# Intel® High Definition Audio Specification

## Document Change Notification

Change Identification: **DCN No: HDA043-A**  
Change Revision: 1.0  
Document Revision: Intel® High Definition Audio 1.0a

### Title: **Energy efficient audio buffering and dynamic FIFO limit change**

Figure 14: HD Audio DMA and buffering

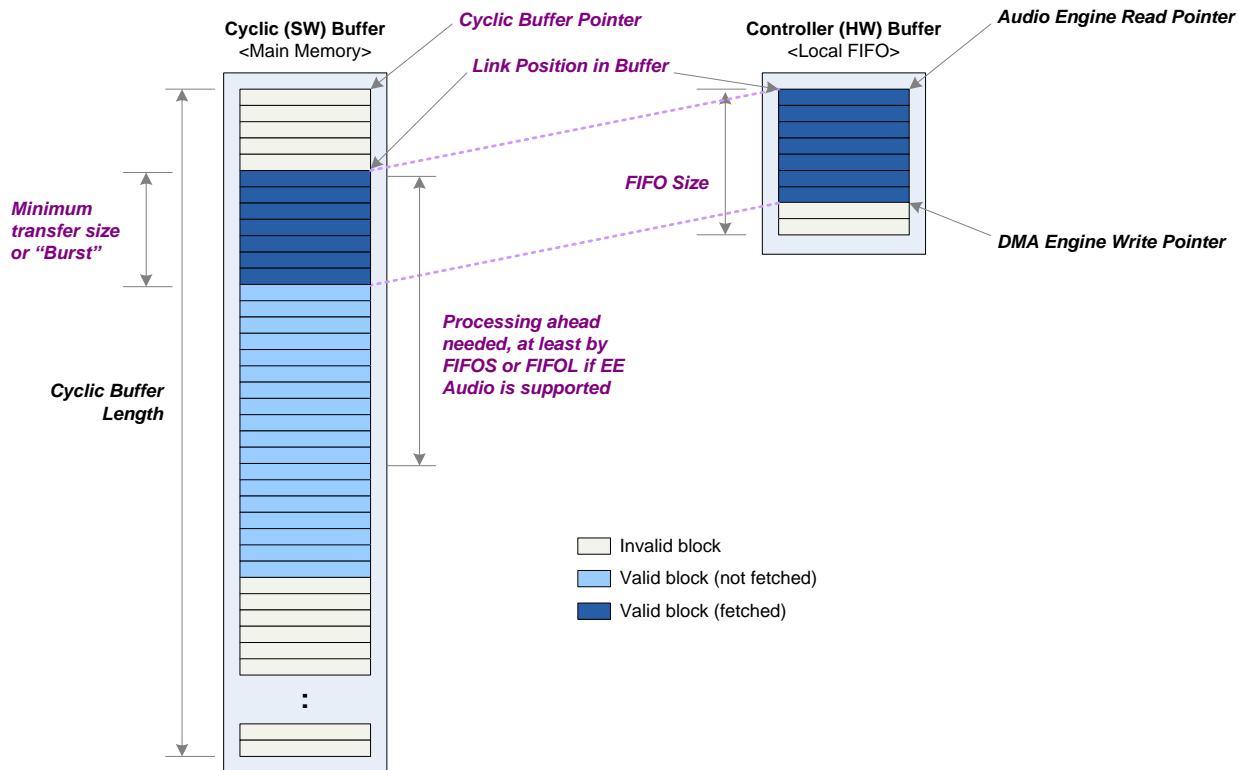
The Energy Efficient HD Audio (EEAudio) mechanism enables the SW to control the HD Audio Controller DMA engine effective buffer size extension for power saving versus latency consideration. When configured to use larger extended buffering, it allows the DMA engine to reduce associated system memory accesses, thus allows the CPU to go in to deeper power saving states and reduces the platform power associated with audio streams. When configured to use smaller extended buffering (or disabled), it suits the application where low latency audio processing is required.

The GCAP2 register EEAC bit indicates the HW capabilities of supporting EEAudio. When EEAC bit is set, the FIFOL register is available for SW to specify the limit (in unit of time) that HD Audio Controller DMA engine can access in the Cyclic Buffer, ahead of the Link Position in Buffer; in other words, that defines the maximum limit that DMA engine effective buffer size (in number of bytes) can be extended to. SW shall guarantee processing ahead of this boundary in the Cyclic Buffer. Note that the translation of FIFOL value to effective buffer size needs to take into consideration of number of channels, sample size, multiplier, divider, and base rate.

When EEAudio is supported as indicated by EEAC bit being set, the FIFOS register will expose the minimum buffer size required by HW for efficient operation. SW can allow the extension of the DMA engine effective buffer size beyond the minimum buffer size advertised in FIFOS register for better power management, by writing to FIFOL register followed by setting FIFOSC bit. Depending on the eligible HW buffer size available, DMA engine can then extend its effective buffer size to a value not exceeding the FIFOL specified. Note that some HD Audio Controller DMA engine implementations are capable of changing FIFOS register value based on FMT register programmed, hence, SW shall always read the FIFOS register to find out the FIFO size advertised before writing to FIFOL register.

The FIFOL register and FIFOSC bit implementation of the EEAudio may support static mode or dynamic mode of programming, as indicated by the DFFLCC bit in GCAP2 register. When static mode is supported, FIFOL register is only allowed to be programmed before the RUN bit is set for the very first time of an audio stream being played. When dynamic mode is supported, the FIFOL register may be programmed even when the RUN bit remains set (in addition to the static mode of programming behavior).

Steps involved in FIFO re-sizing:

- 1) Software writes a new value in FIFOL register.
- 2) Software sets FIFOSC bit to 1 (from 0).
  - a. Hardware will clear the FIFOSC bit (to 0) once it has completed the resizing.
  - b. For static programming mode, this typically happens almost immediately.
  - c. For dynamic programming mode, this may take up to the streaming time required for flushing the prior effective FIFO size content (i.e. up to the prior FIFOL value in unit of time).
- 3) SW can request next resize only after the FIFOSC bit is cleared by HW.
